ADDENDUM NO. 4

E. Bunnell Ave./Charles Way Water & Sewer Main Extension

CITY OF HOMER, ALASKA

Addendum Issue Date: January 6, 2023

SS-1

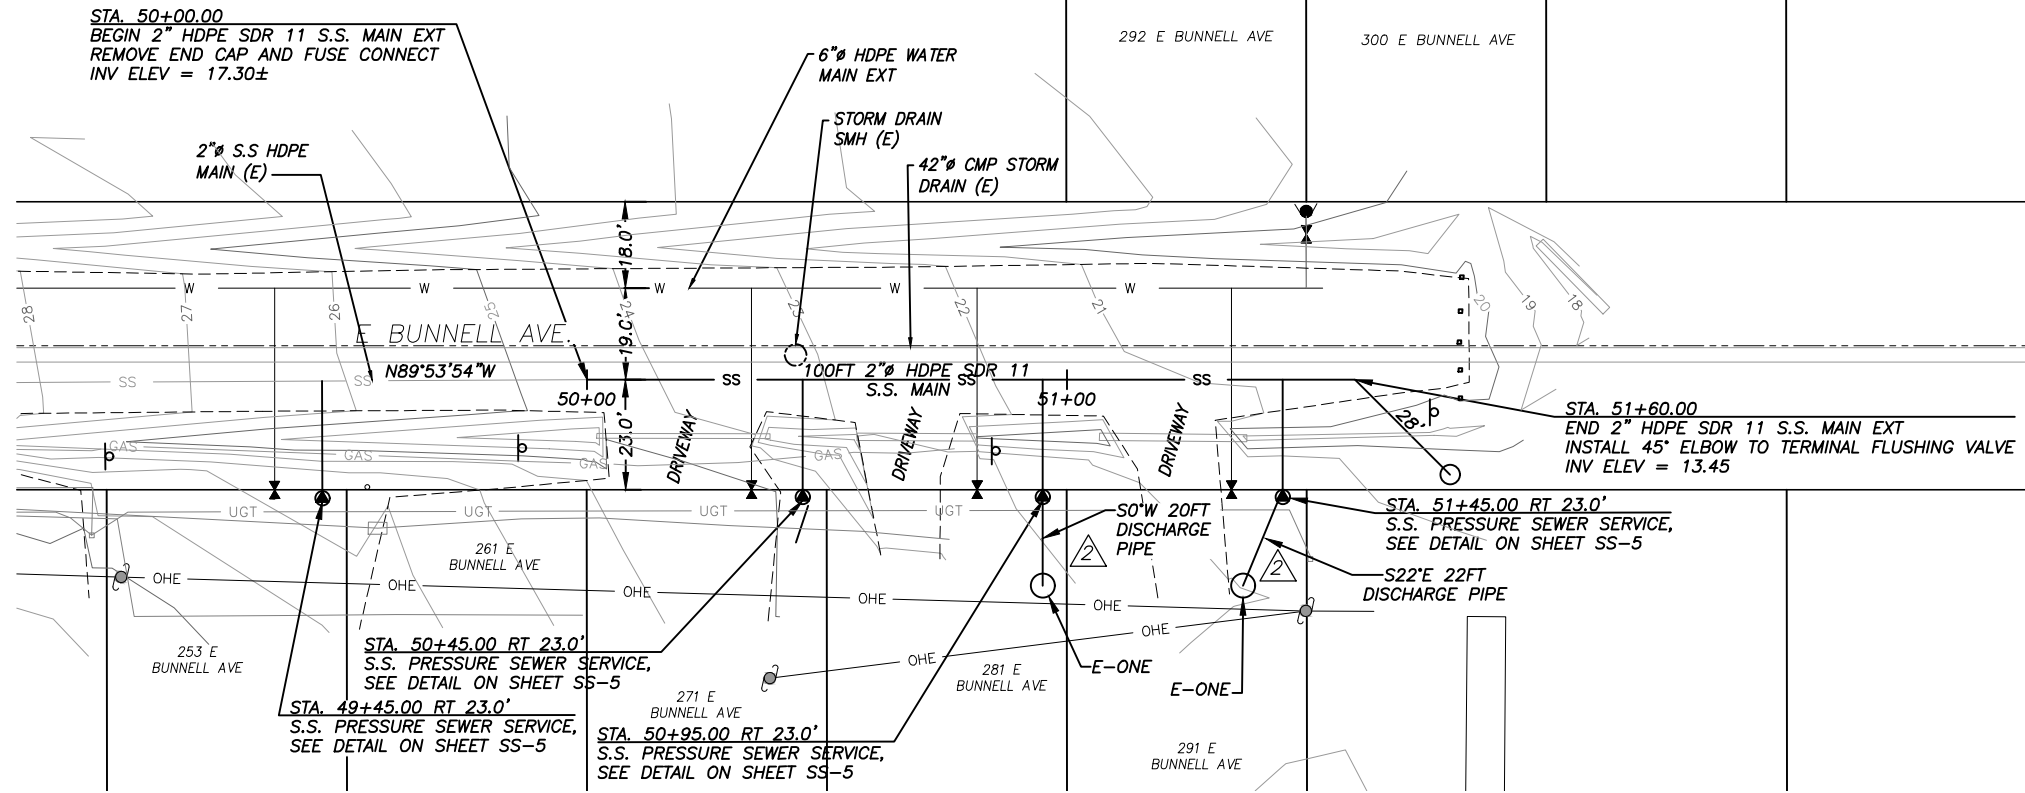
3. Several issues with the Plans were brought up during the pre-bid meeting:
 1. On sheet SS1, note 2 said "No E-One units installed for services shown on this sheet" but note 5 said to install E-Ones at 281 and 291 E. Bunnell Ave. Sheet SS1 has been revised to show E-Ones installed at 281 and 291 E. Bunnell Ave. with no contradictory information.

4. A potential bidder requested on-property details for properties with E-One's. New plan sheets SS1, SS3 and SS4 show locations for E-Ones and the lengths of connected discharge pipes.

REVISIONS			
NO.	DESCRIPTION	DATE	APR
1	NOTE 2 DELETED, NOTE NUMBERING REORDERED	1/12/23	JSB
2	E-ONE AND DISCHARGE PIPES ADDED TO PLAN	1/12/23	JSB
3	NOTE 4 REVISED	1/12/23	JSB

SHEET NO.:
SS-2

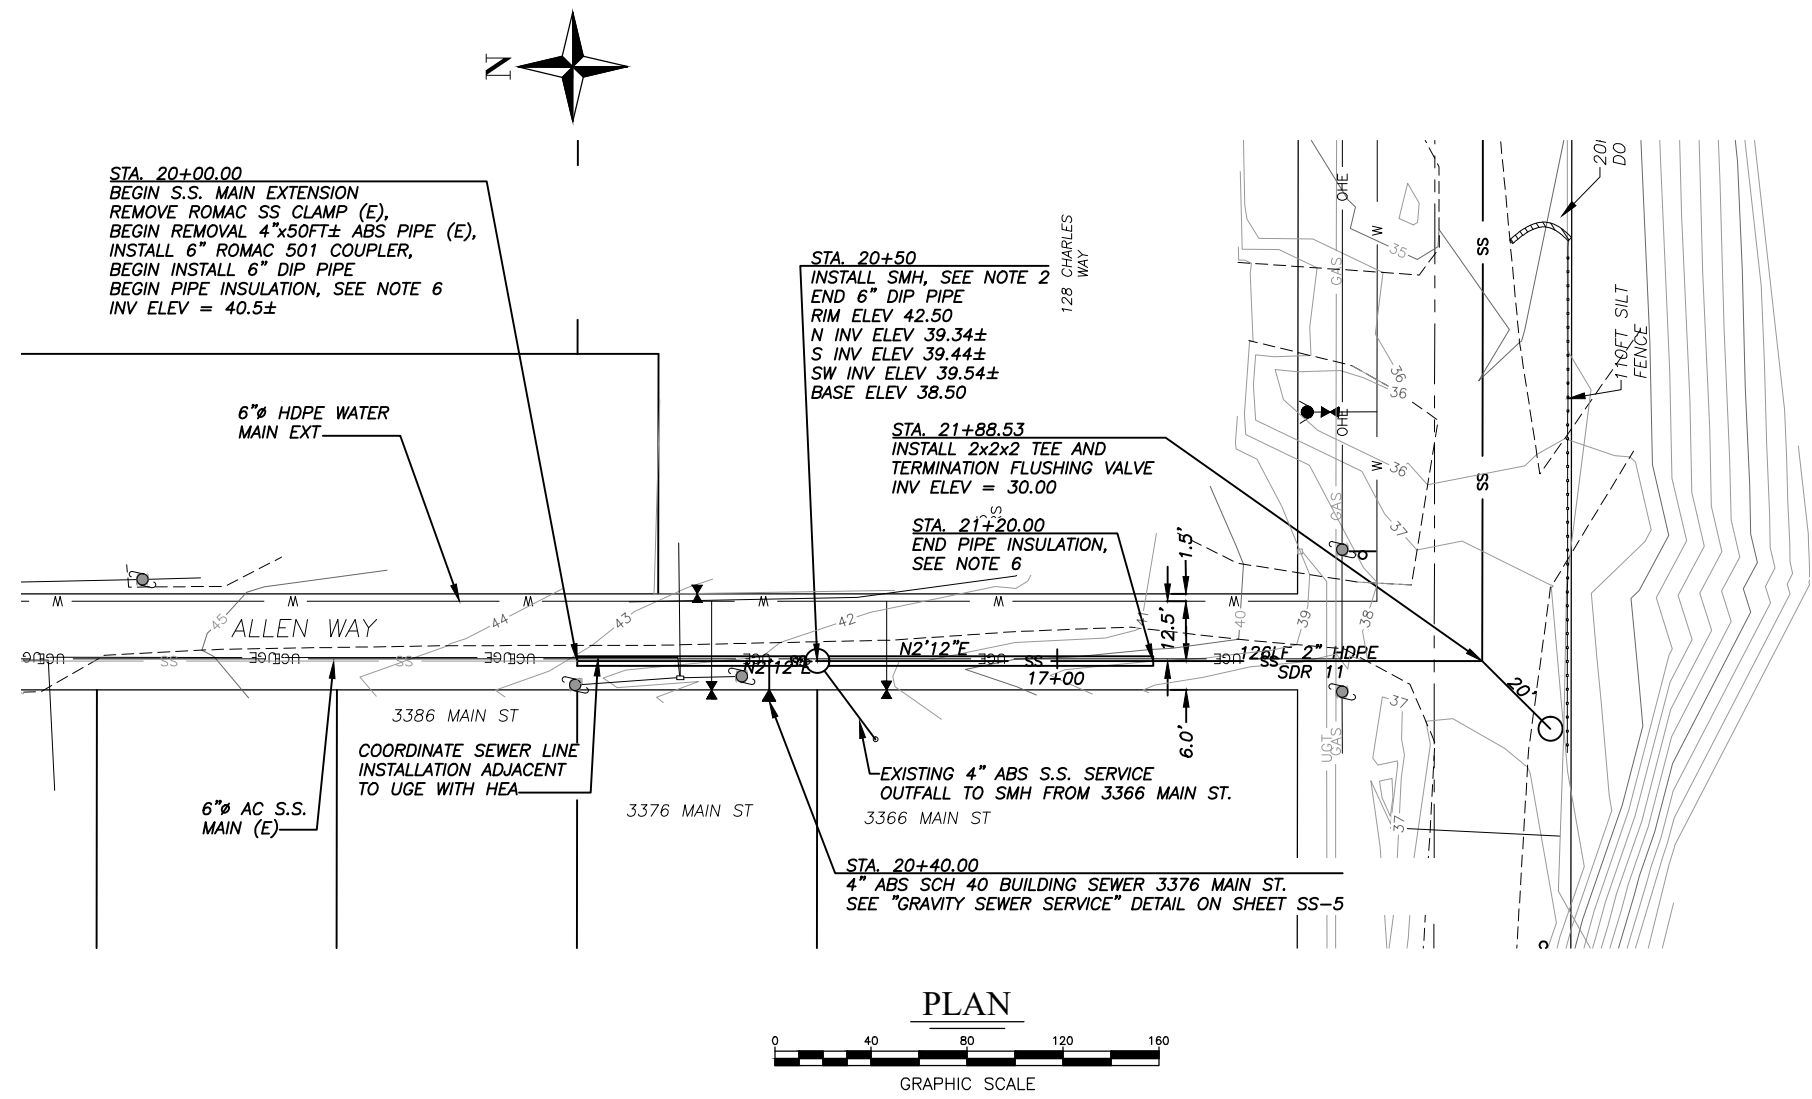
2. On sheet SS2, note D3 said to use 8-mil polyethylene for encasement of the sewer manhole. An updated sheet changing the encasement to coal tar pitch meeting ASTM D-450 has been attached.

6. The UGE line adjacent to the sewer line on Allen Way was called out in the water plans. The attached W-2 and SS2 sheets have moved the callout to SS2.

REVISIONS			
NO.	DESCRIPTION	DATE	APR
1	MODIFIED UGE CALLOUT ADDED	1/12/23	JSB
2	REVISED MANHOLE WATERPROOFING	1/12/23	JSB

SHEET NO.:
SS-3

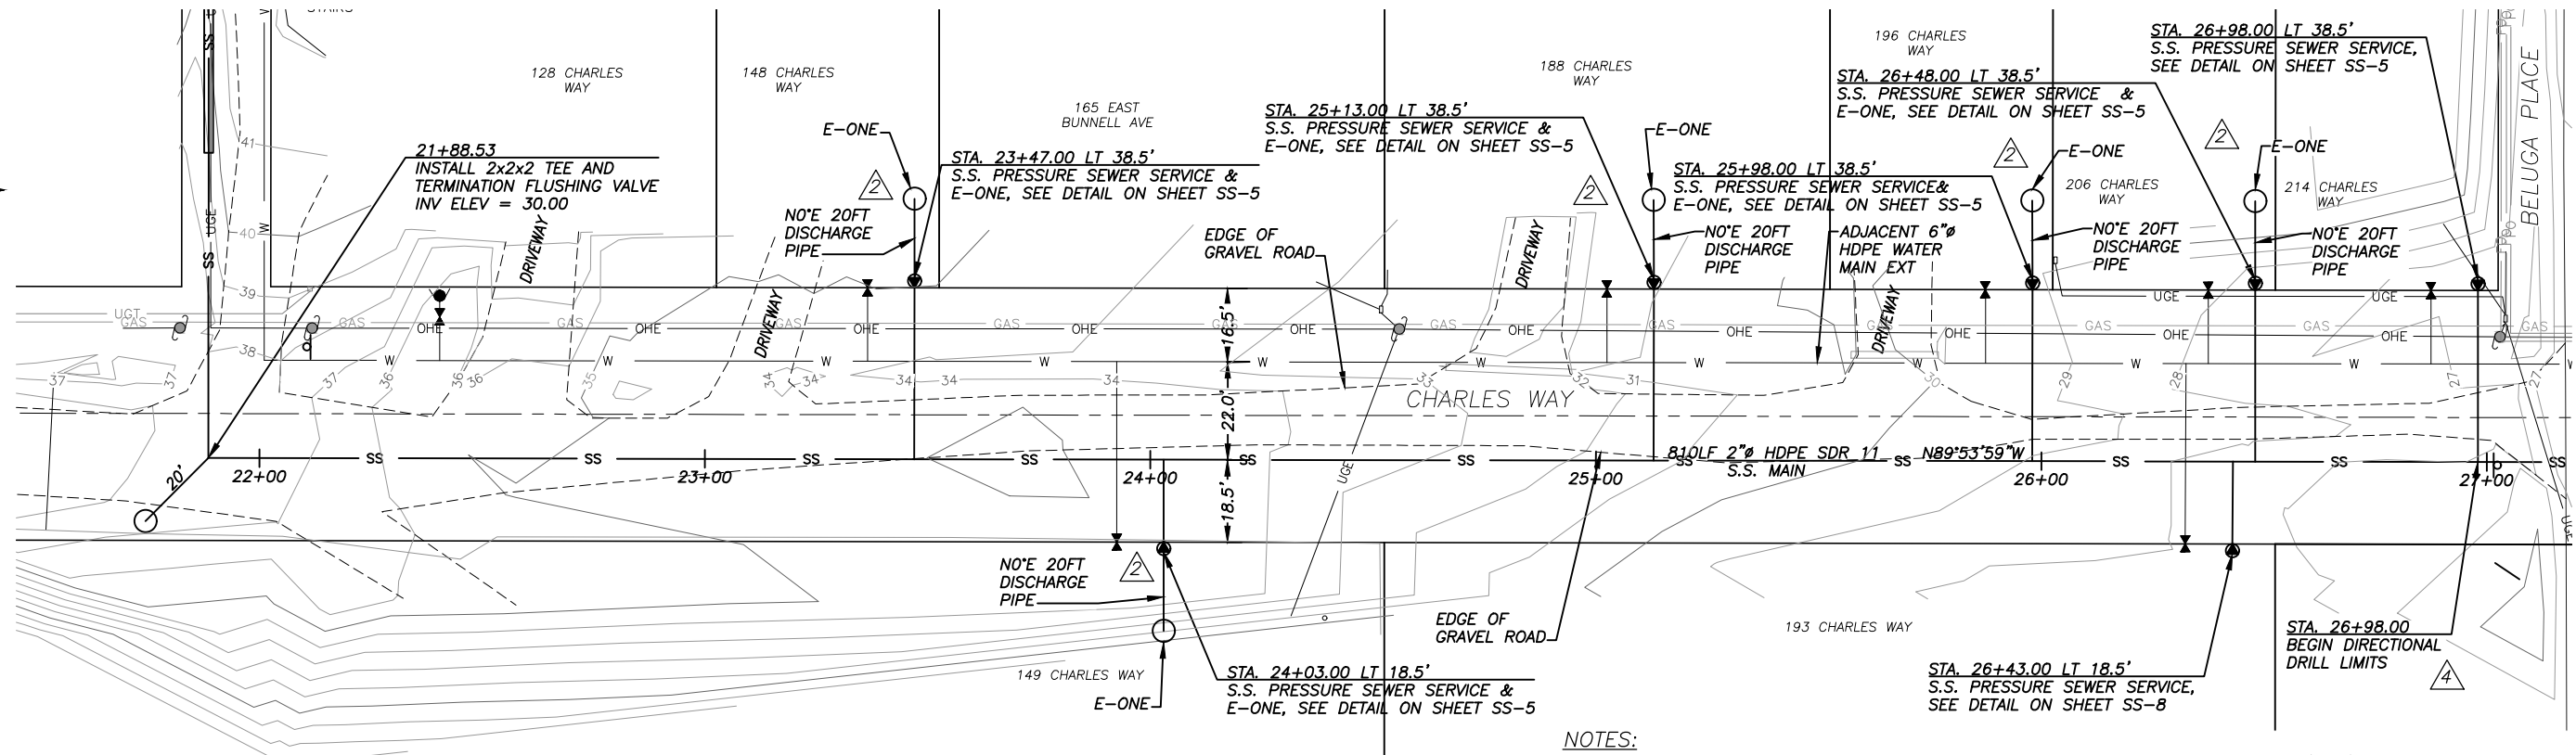
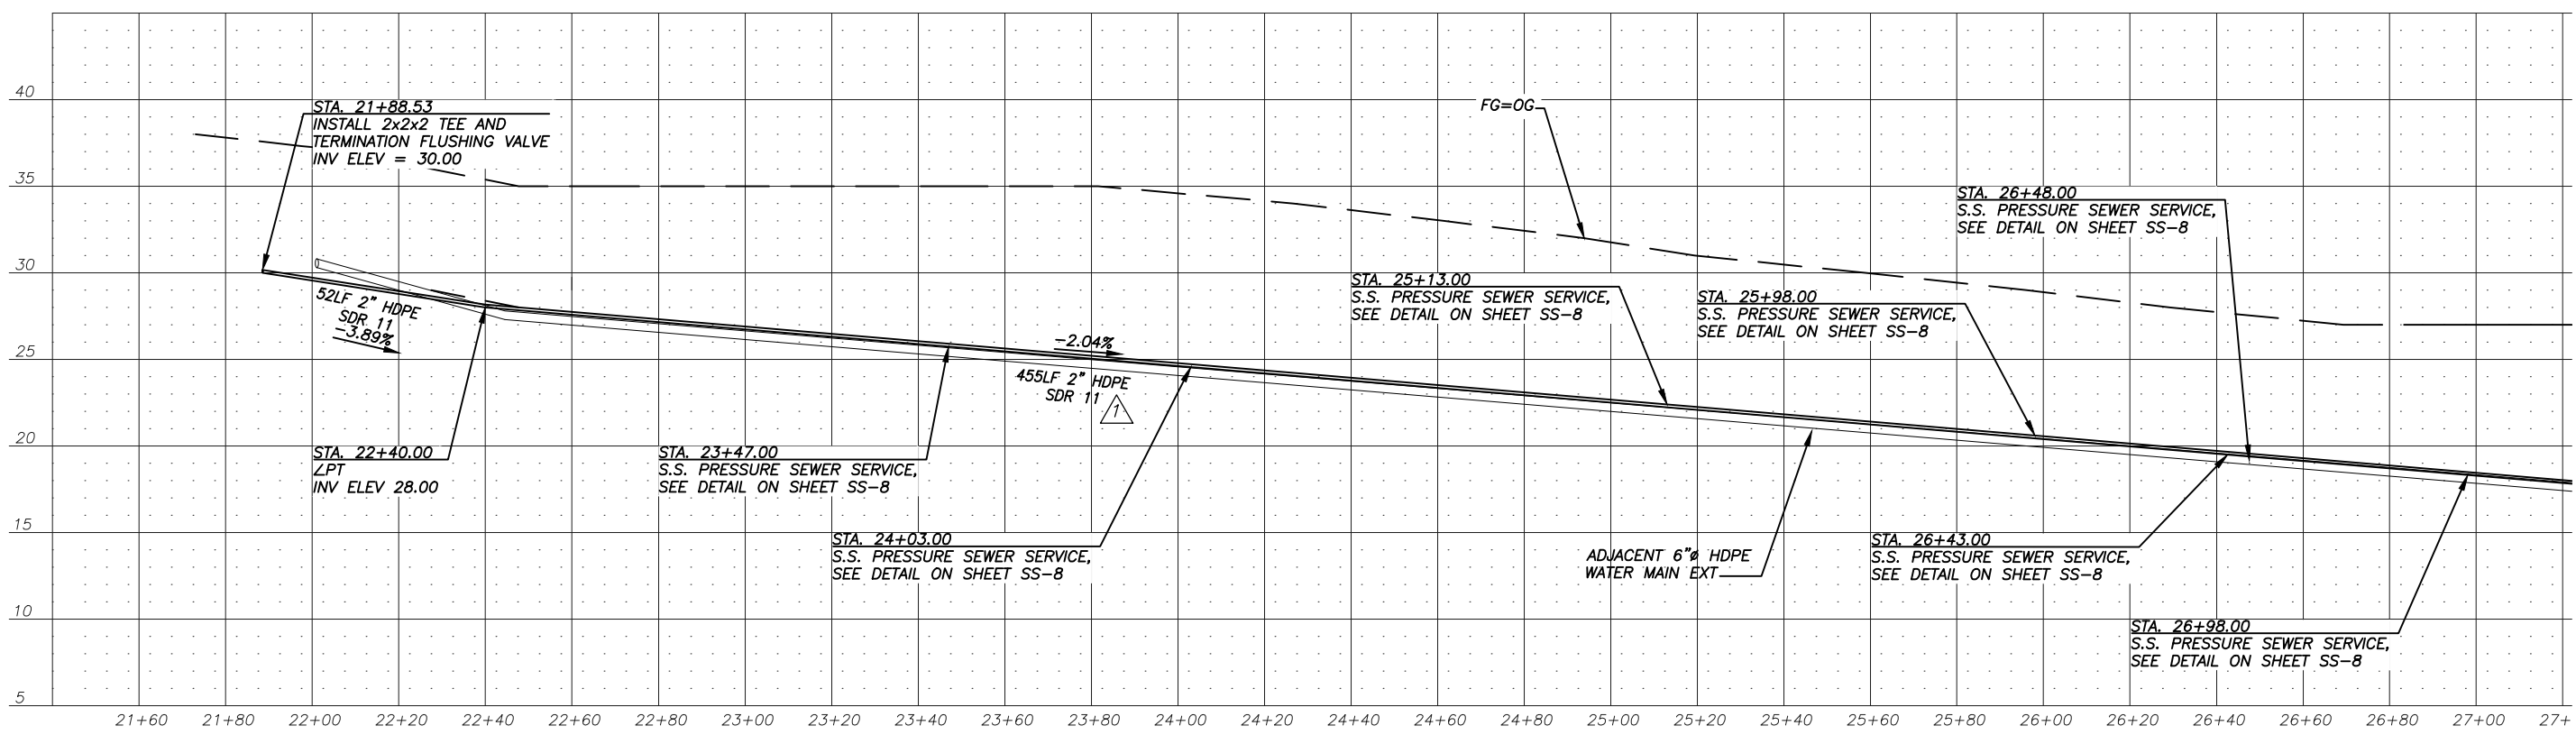
3. On sheet SS3, the profiled called out the Sewer Main as 6" HDPE whereas everywhere else, it was shown as 2" HDPE. An updated sheet is attached with references to 6" HDPE removed.

4. It was discovered that on sheet SS3 of the Sewer Plans, the beginning limit of directional drilling was not established, but there is an end limit on SS4. The new SS3 sheet shows the beginning limit of directional drilling.

REVISIONS			
NO.	DESCRIPTION	DATE	APR
1	WATER MAIN SIZE CORRECTED	1/12/23	JSB
2	E-ONE AND DISCHARGE PIPE ADDED TO PLAN	1/12/23	JSB
3	NOTE 2 REVISED	1/12/23	JSB
4	BEGIN DIRECTIONAL DRILL CALLOUT ADDED	1/13/23	JSB

**E. BUNNEL AVENUE / CHARLES WAY / ALLEN WAY
 SANITARY SEWER MAIN EXTENSION
 SANITARY SEWER CONSTRUCTION NOTES**

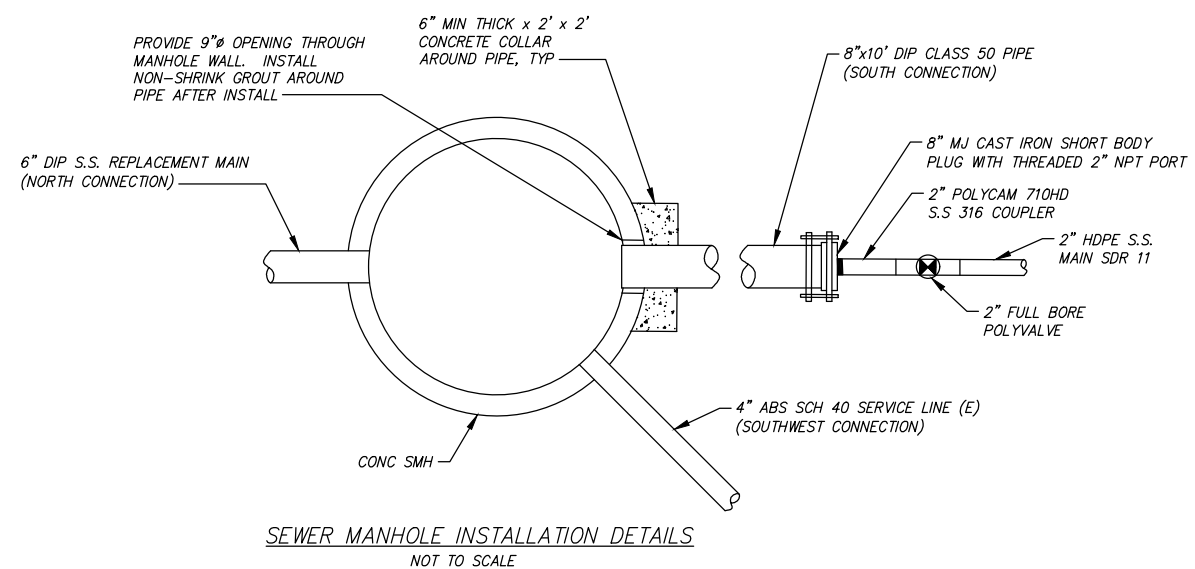
5. On sheet SS6, construction note 1 said that "Directional drilling shall be utilized to install HDPE main pipe wherever open trench installation is not required to place hardware fittings and assemblies, valves, tees, insulation board , manholes, and casing." An updated sheet is attached changing this to "Directional drilling shall be utilized wherever required in the Plans and at the option of the Contractor at other locations."

- DIRECTIONAL DRILLING SHALL BE UTILIZED TO INSTALL HDPE MAIN PIPE WHEREVER REQUIRED IN THE PLANS AND AT THE OPTION OF THE CONTRACTOR AT OTHER LOCATIONS.
